## **STAFF REPORT FOR THE HISTORIC REVIEW BOARD**

**FILE NUMBER:** DR-11-09

**REQUEST:** Garage rehabilitation and carport addition

## **Garage Door**

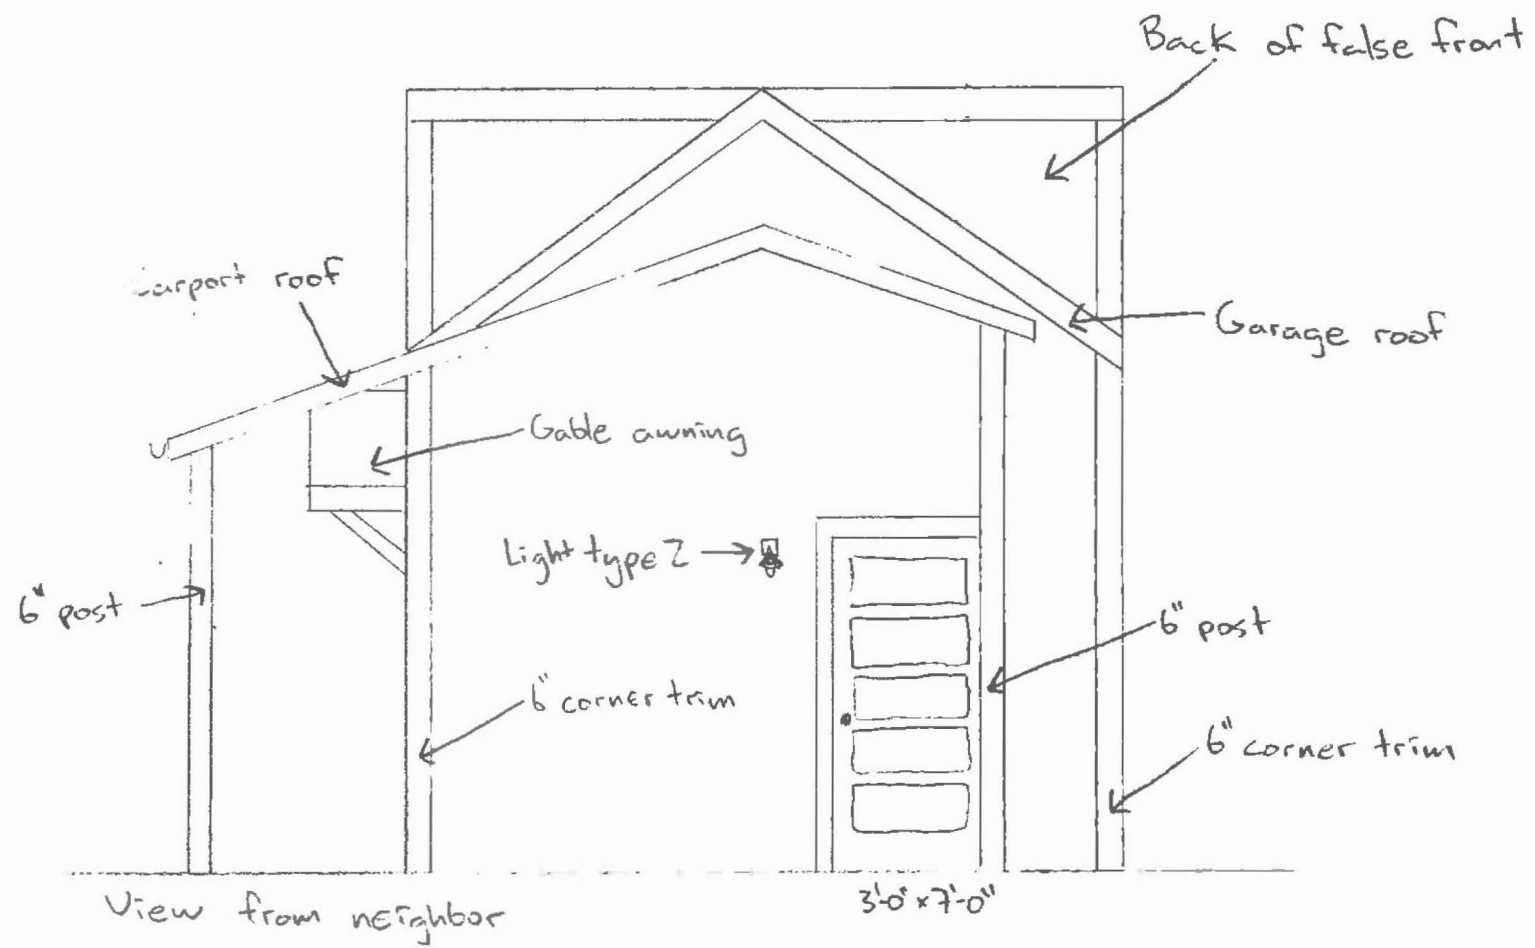
The proposed plans call for altering the front elevation by removing the man door and then centering and enlarging the garage door to accommodate a 9' carriage style garage door. This changes the character of the façade. However, it is not possible to have a standard size man door (36" width) and a standard size garage door (8' or 9' width) given the width of the existing garage. The elevation must be altered for the structure to serve as a functioning garage. While staff would prefer to not see this change, it is not possible for the garage to function as a garage without this change. The proposed garage door is carriage style in appearance and consistent with the architectural character of the residence.

Standard C: The applicant is proposing to replace the existing garage doors. However, these doors are not historic and the proposed replacement door, while an overhead door, has an appearance consistent with the existing doors.

Option B, 2

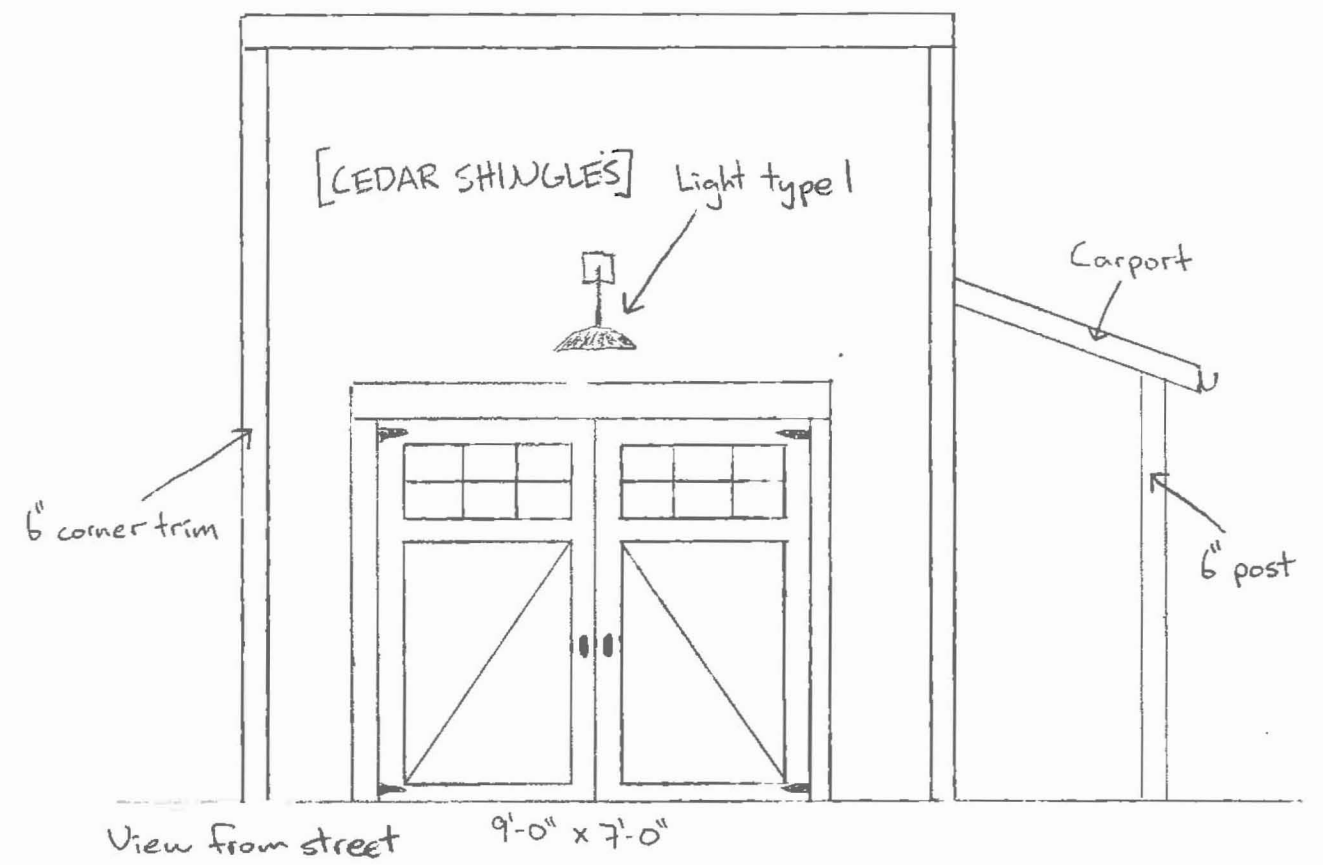
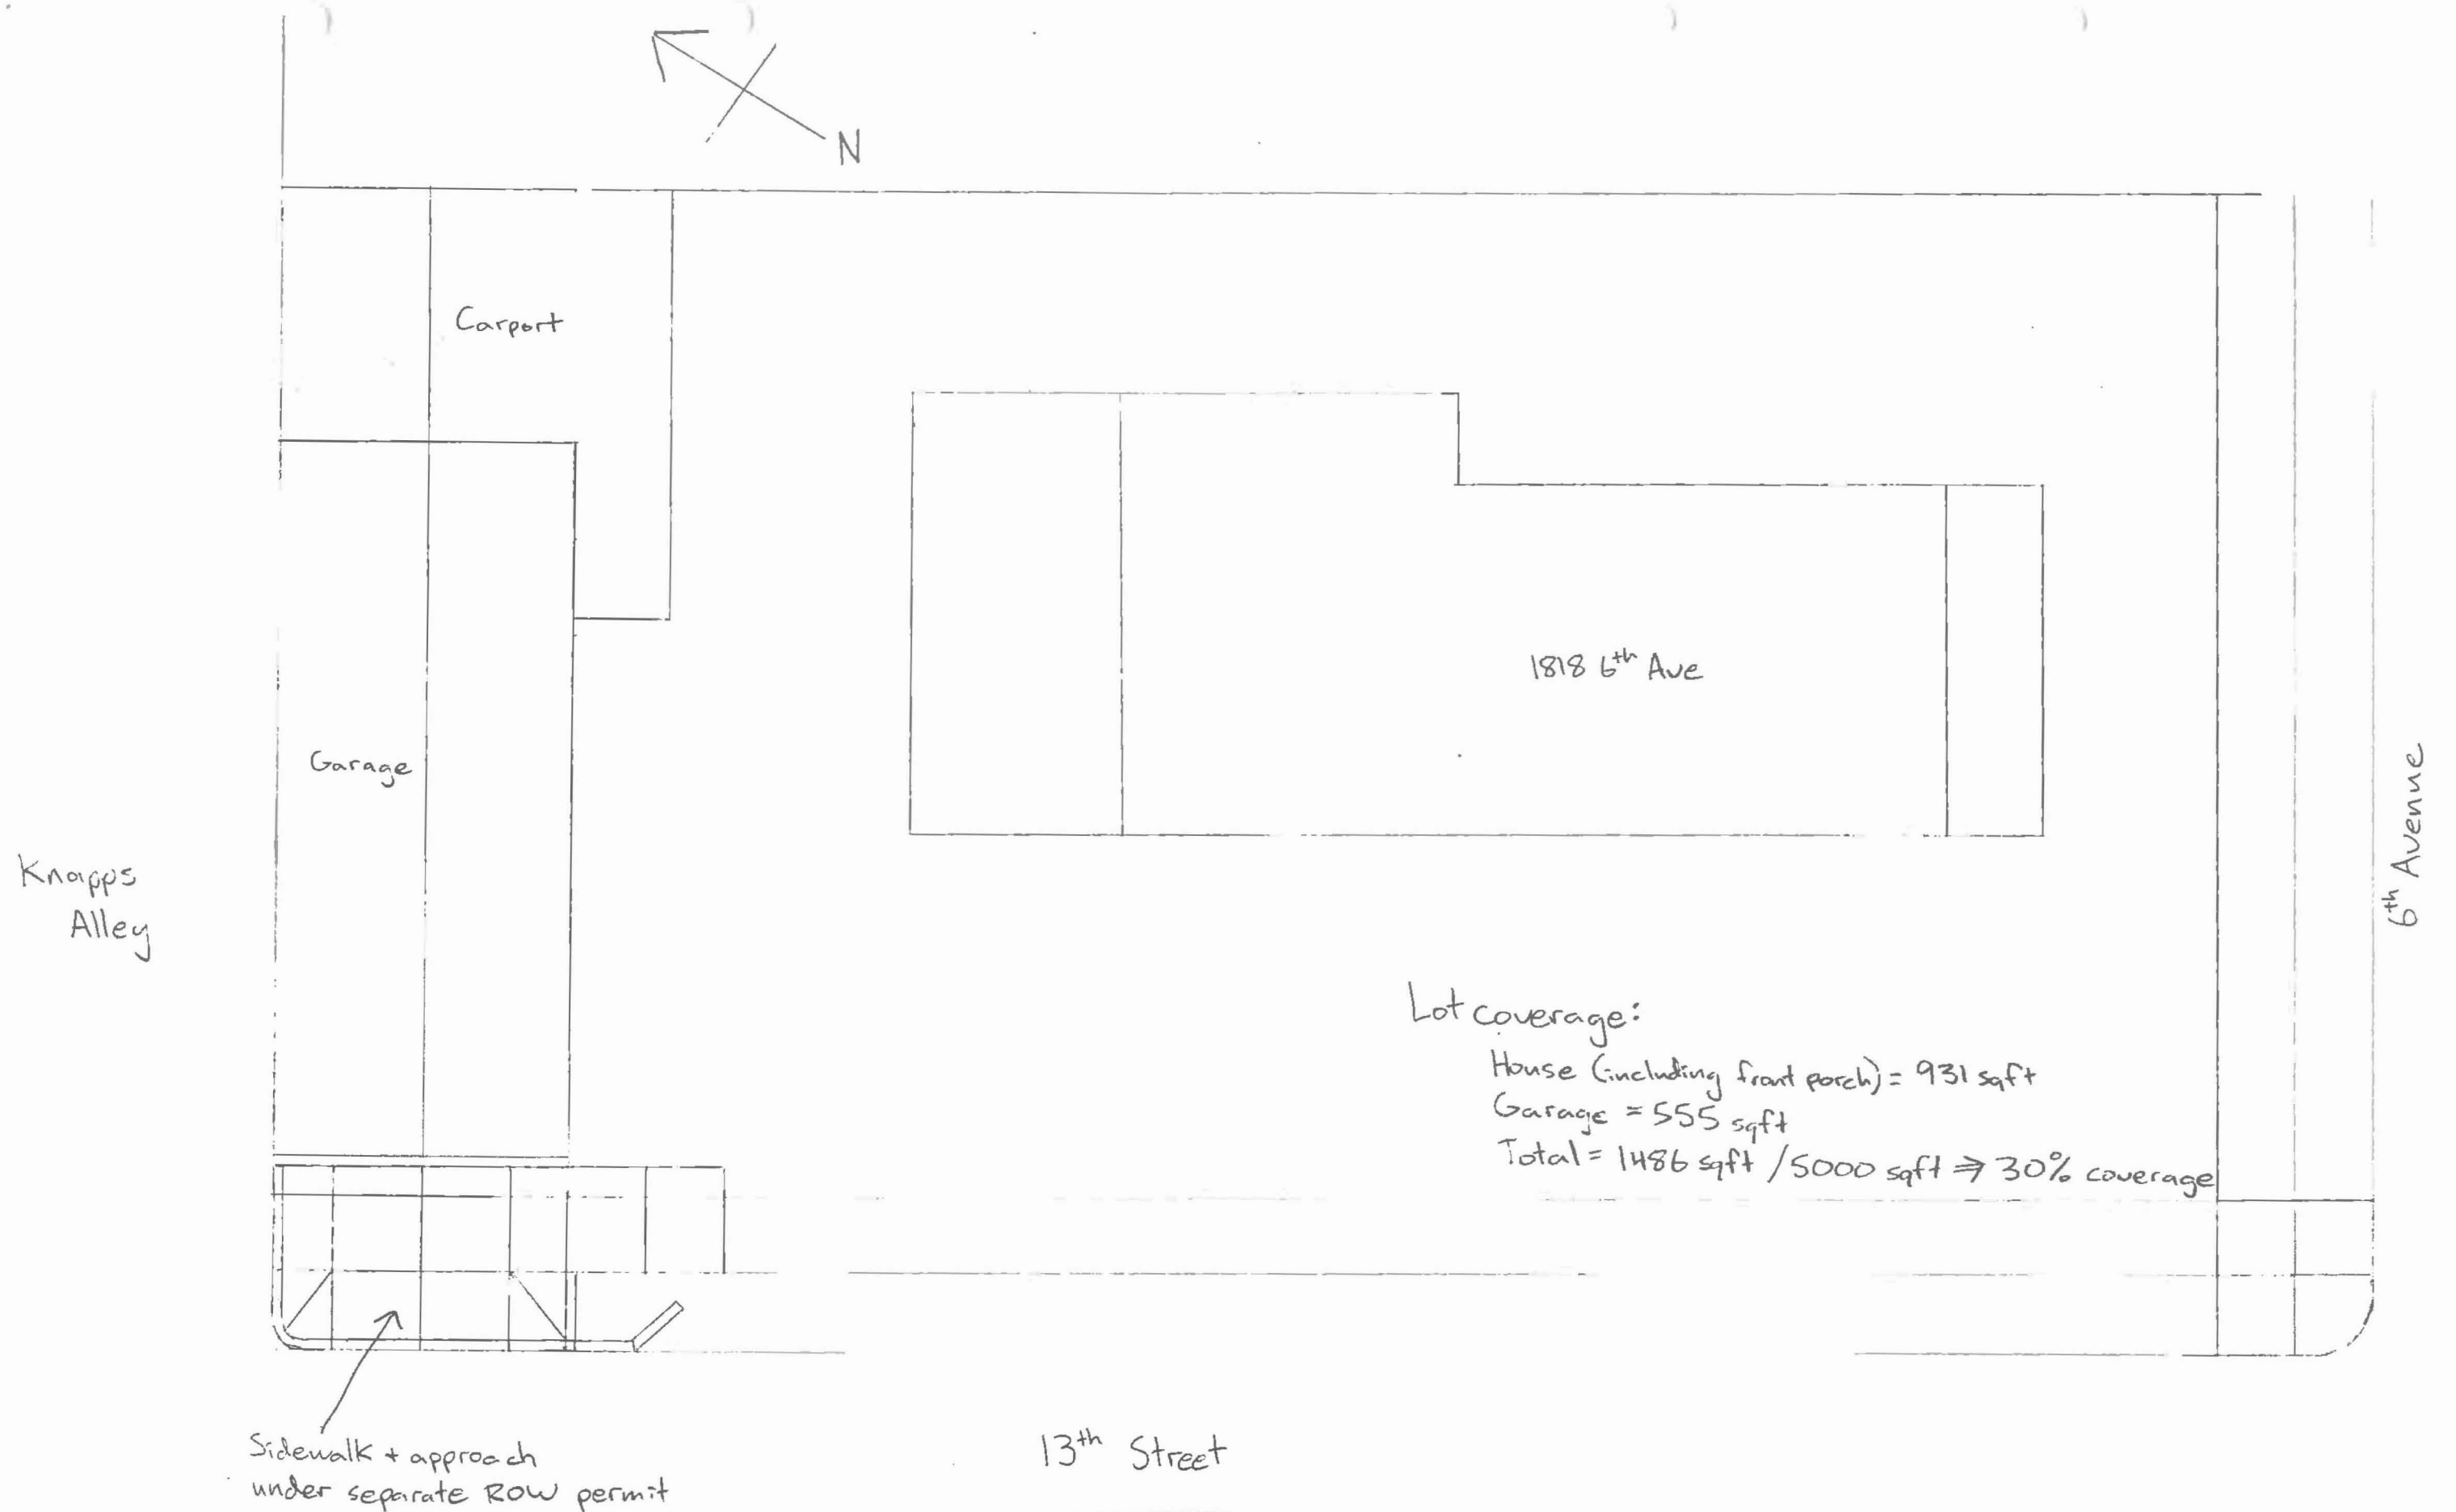
In addition, the plans for Option B do not show the required 3' rear setback for the carport. Compliance with this setback requirement is necessary and would be a condition of approval for Option B.

- 4) I noticed the mistake on the 3' setback in option B after I turned in the plans. It is my intent to comply with the required set back as shown in option A. I will correct the option B plan and drop 2 hard copies at your office tomorrow or next Tuesday.
